From: Watkins, Robert
Sent: Wednesday, September 22, 2021 2:28 PM
To: Habbab, Karim
Cc: Werner, Jeffrey B
Subject: September 2021 BAR Decision

BAR 21-09-04

Project: Install lighting at Sanctuary entry

301 East Jefferson Street
Clarifications.
September 2, 2021

SANCTUARY ENTRY - LIGHTING

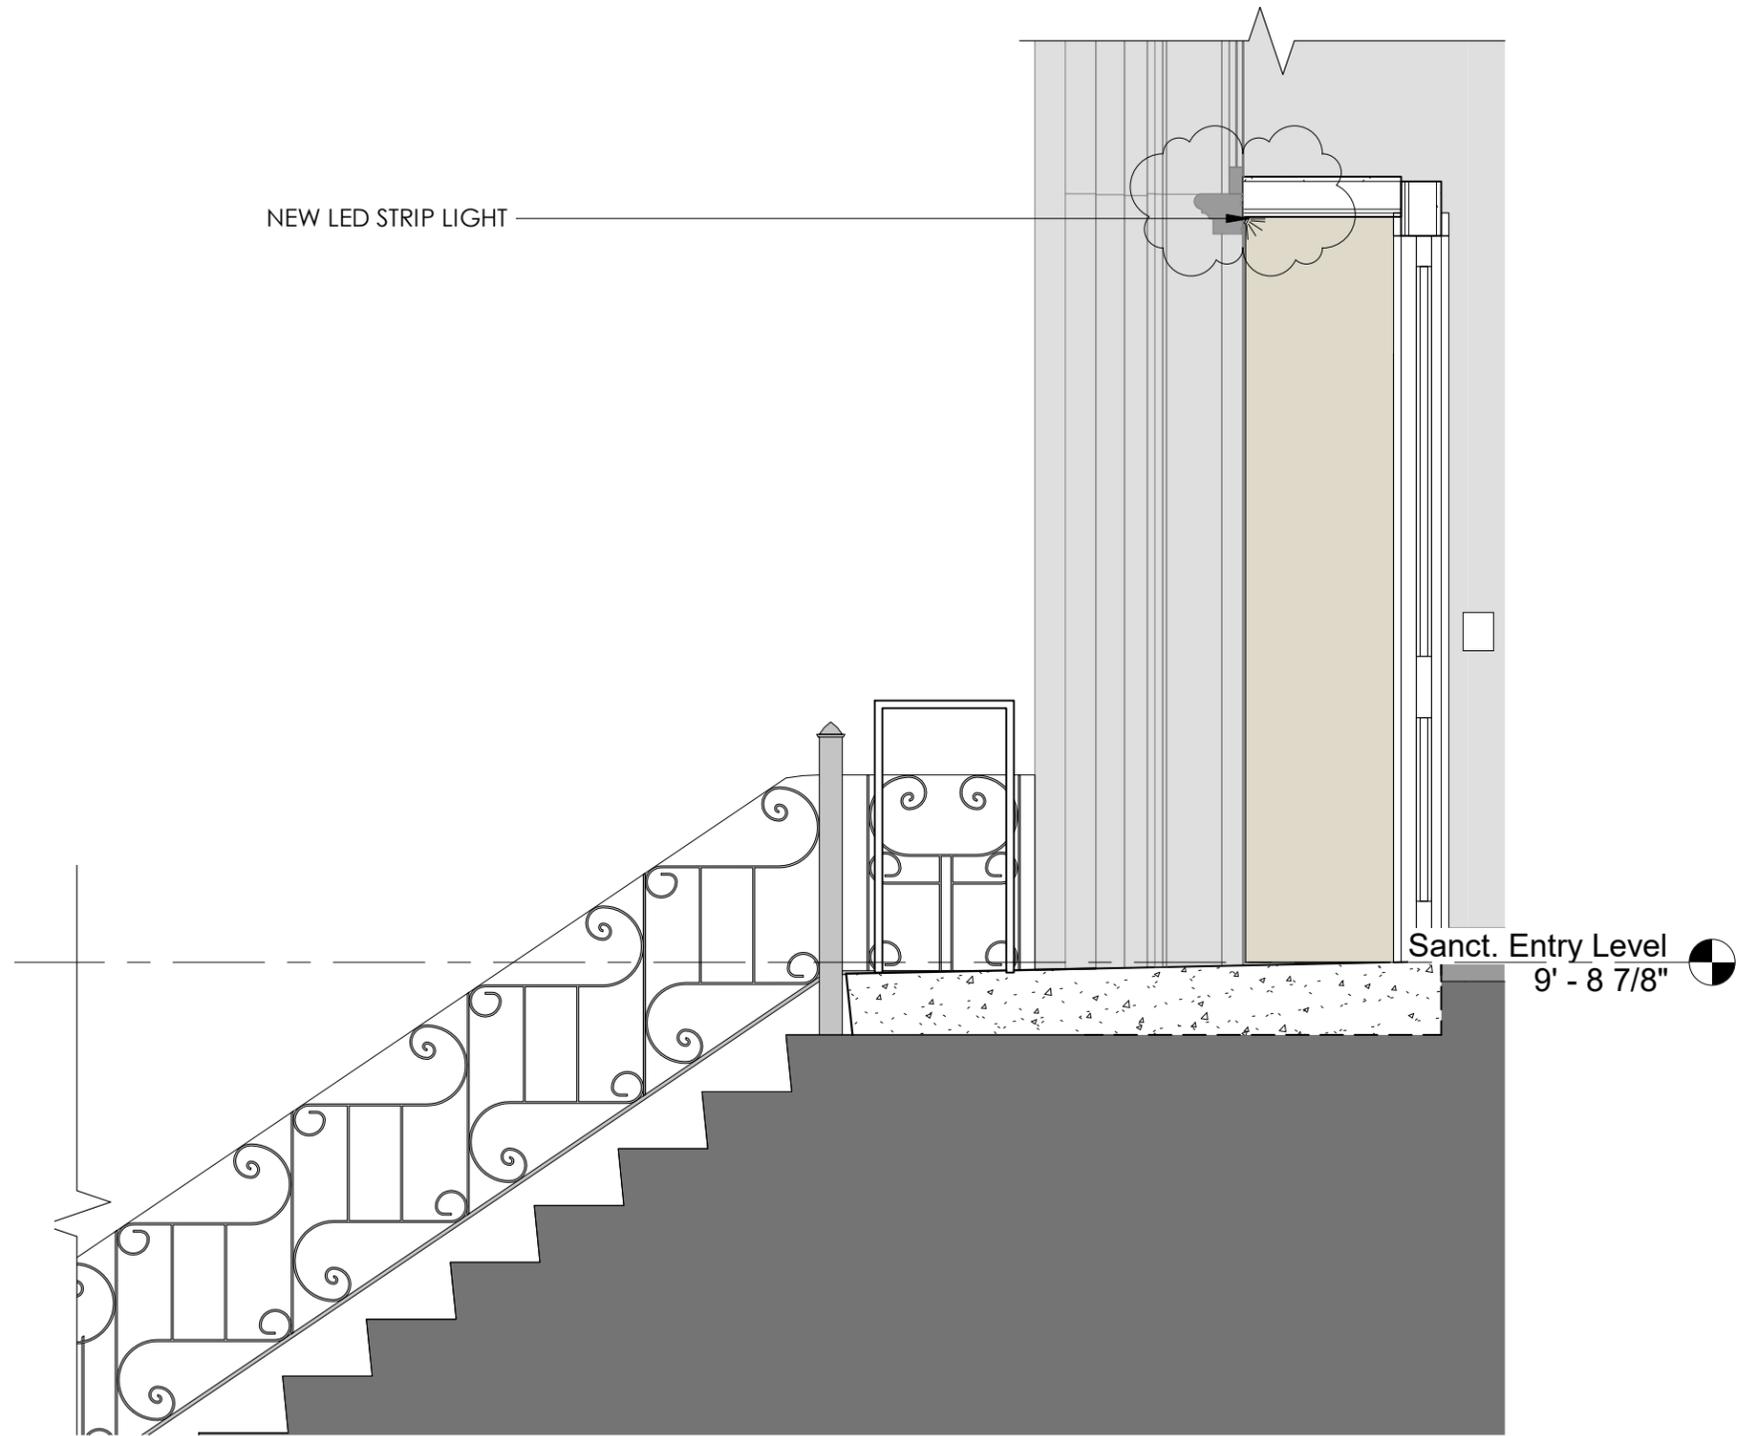
Proposed LED strip lighting will be concealed behind trim. Lamping is dimmable, the Correlated Color Temperature does not exceed 3,000K, and the Color Rendering Index is not less than 90.*

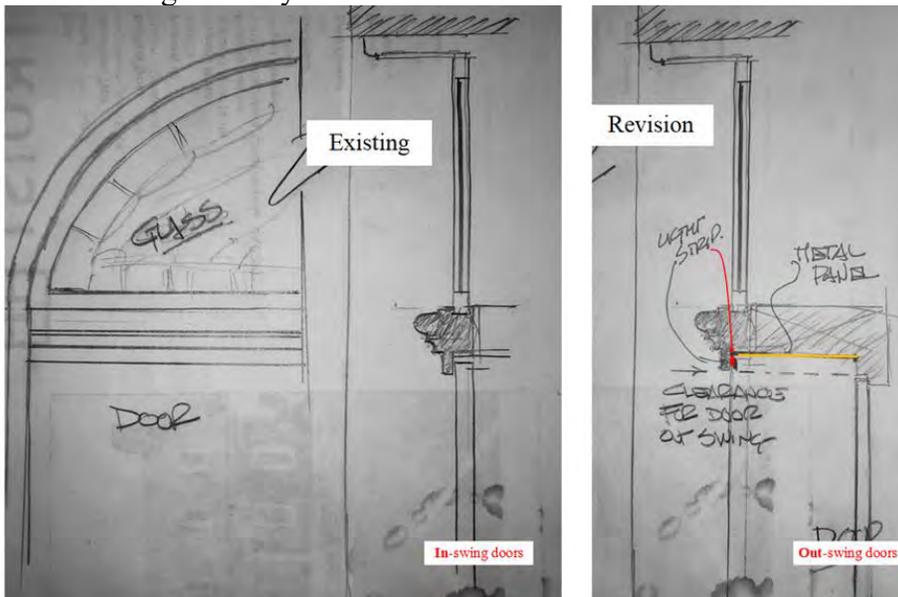
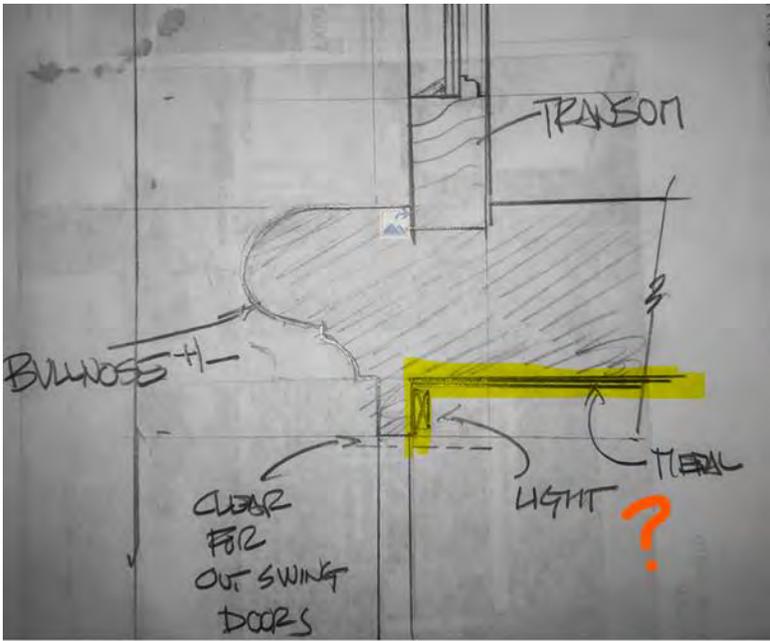
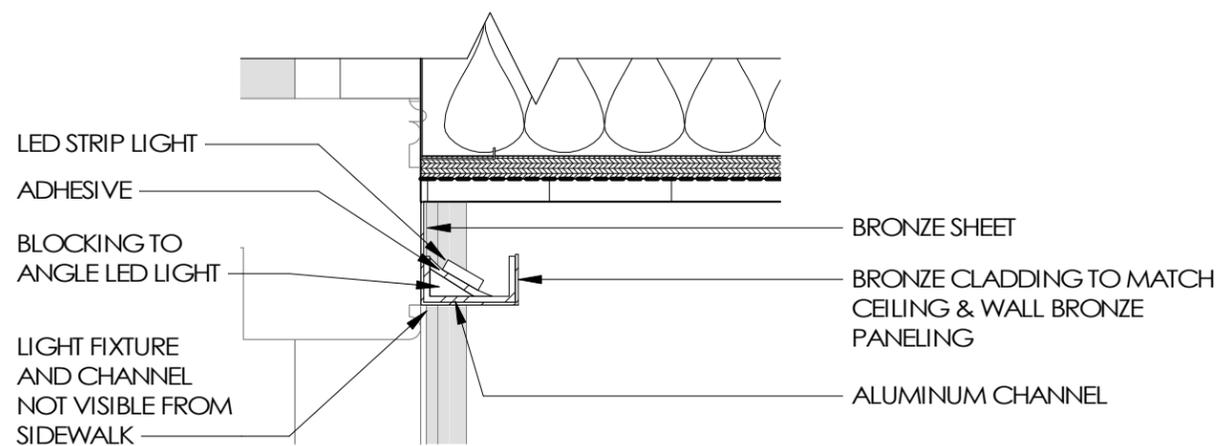
Staff: Something is off between the old and new wall section.

Staff: Forgive my rough sketches below. As I interpret your drawing plan, the head trim (the bullnose, exterior door stop, etc.) will remain in place, with the light strip fitting onto that door stop, more or less. Is that correct?

Applicant: New sketch is modeled more accurately on field measurements and is more reflective of existing conditions.

Applicant: Sketch is spot on. The light fixture is intended to be hidden from view from the street/front yard. The new door will be a bit shorter to make sure it can clear the existing jamb when it swings out as you have noted as well in the bottom sketch.
